**CITY OF SEATTLE
ANALYSIS AND RECOMMENDATION OF THE DIRECTOR OF
THE DEPARTMENT OF PLANNING AND DEVELOPMENT**

DPD Application Number: 3012748
Clerk's File Number: 312087
Applicant Name: Luis Ramirez - Seattle Public Utilities (SPU)
Address of Proposal: 5080 Beach Dr SW

Council Land Use Application to allow an expansion of an existing public facility (Pump Station #39) in an Environmentally Critical Area (ECA). Project includes the installation of a 40 sq. ft. emergency generator on a 228 sq. ft. concrete pad and 20 cu. yds. of grading. Determination of Non-Significance prepared by Seattle Public Utilities.¹

Mapped ECAs on Project Site

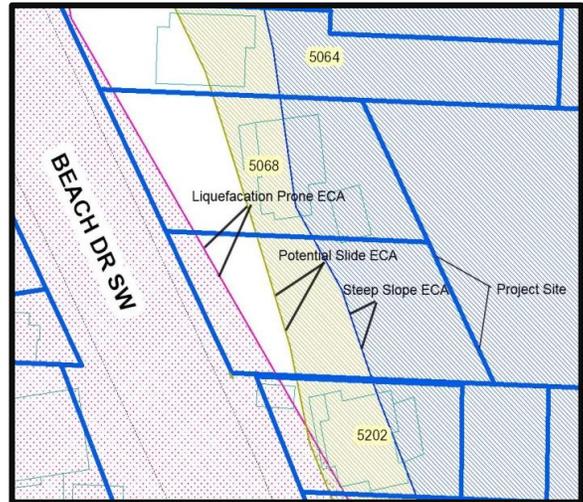
The parcel contains ECAs: a Liquefaction Area on the western 1/2, a Potential Slide Area on the eastern 3/4, and Steep Slope areas on the west 1/4 and east 1/3. The existence of these ECAs creates a disagreement between the project's compliance with the City's ECA provisions and compliance with the Land Use Code applicable development standards. Placement of the project in the middle of the parcel (out of required yards) would have been fully compliant the Land Use Code standards for yards but would have directly impacted the Potential Slide Area and the 15' buffer applicable to the Steep Slope. Both of these ECAs are currently vegetated with a mature native plant community. Impacts would be associated with clearing vegetation and disturbing soils in these ECAs for the generator and new access stair.

Locating the project adjacent to the Beach Drive SW street right-of-way minimizes amounts of grading and impacts to ECAs but requires waiver or modification of development standards due to the front yard location as described in this analysis. The current siting location minimizes clearing of native vegetation, minimizes ground disturbance, mitigates noise and view impacts to neighbors, and incurs less cost to SPU and its ratepayers. Further, the front yard location does locate the generator's noise and exhaust farther from the abutting neighbors to the north and south who are most affected by the proposal. As currently proposed, the project would be located in a Liquefaction Area and Steep Slope Area. However, this location has been previously disturbed by removal of native vegetation, terracing, and construction of rock retaining walls. SPU processed an ECA exemption for the project contingent upon the proposed option due to its minimal intrusion to the ECAs as possible, the ECA exemption is located in the project file

Photo simulation view of site from Beach Drive (Option 1, Proposed Front Yard Location)

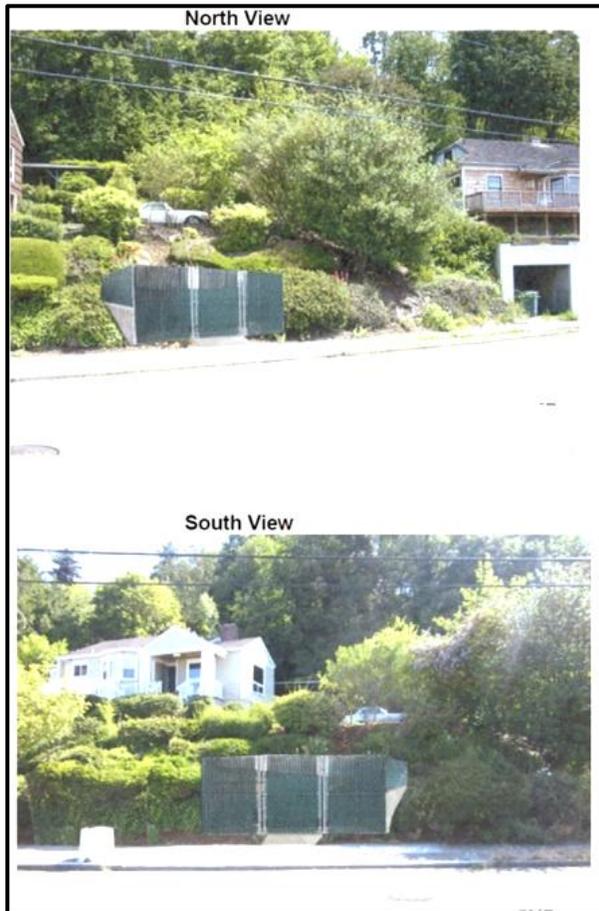
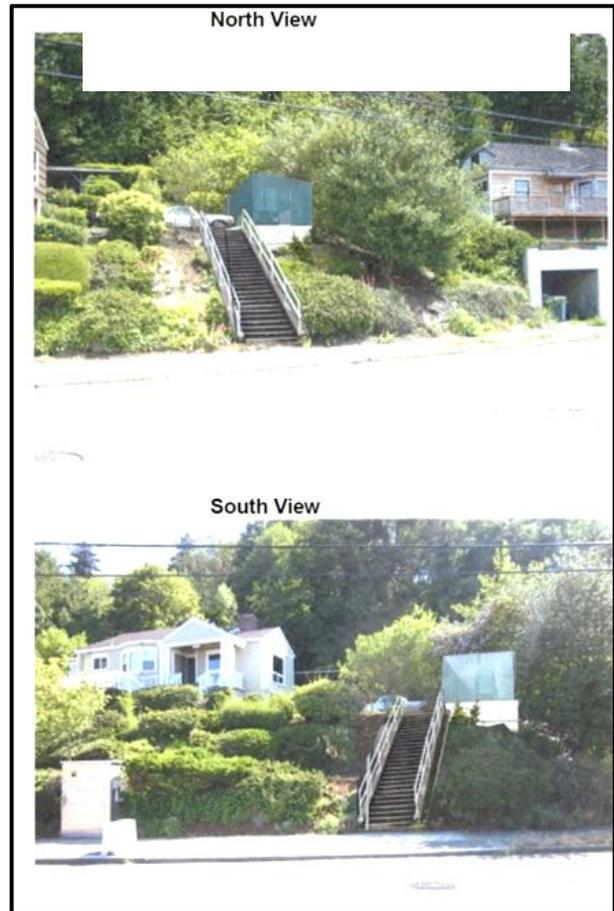
SPU provided two photo simulations, the proposed front yard location (Option 1) and a Code Complying design (Option 3) (see graphics below). The underground option is not shown; but it would not be visually perceptible to do its subterranean location other than an access hatch.

SPU didn't hold its own official public meetings for the project but did meet with the abutting property owners, those who would be most affected by the proposal. DPD did publish and mail notice of application for the project. The preference of the abutting neighbors was to locate the generator at the street rather than in the principal building area (code compliant option #3).

3) Location of Fence/Wall in Yard (Utility Services Uses) (SMC 23.44.022-K.2)	DPD recommends approval, the further the generator and excavation is moved west from the street the greater the excavation amount and height of retaining walls would be needed to accommodate. The code complying option 3 would have the generator located approximately 14' above sidewalk grade, resulting in greater visibility including a new access staircase and greater amounts of excavation to construct. The proposed fence is setback 1'-8" and will accommodate landscaping in areas outside the access path. North and south retaining walls are 5' high from sidewalk grade, which is 1' less than would be permitted for a single family structure within a yard.
